Lloyd's Register of Shipping.

Ship's Name "RADFIELD"

Memorandum of alterations reported since ship was surveyed for assignment of Load Lines in

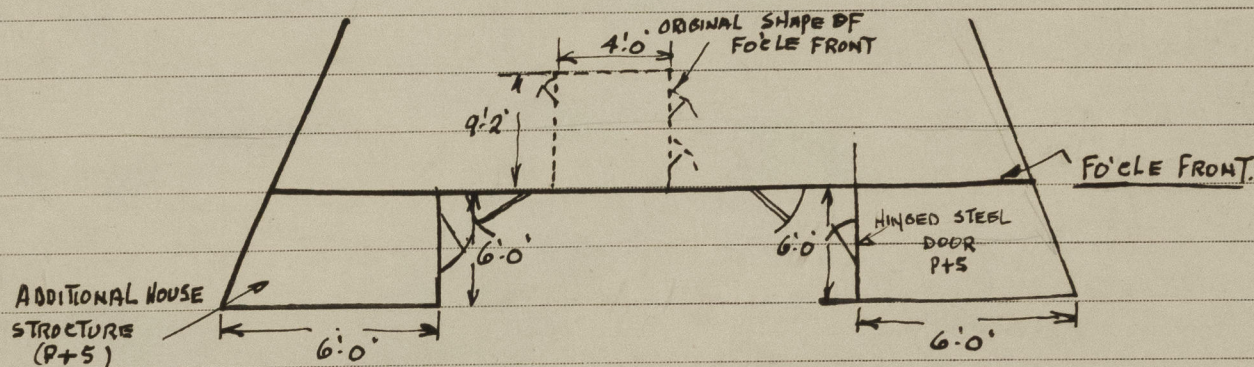
The forecastle front has been amended as shown below.

The original recess in bulkhead now removed and bulkhead plated across having 2 stronghinged wood doors 4'8" x 21" O.D.S. sill 19" high.
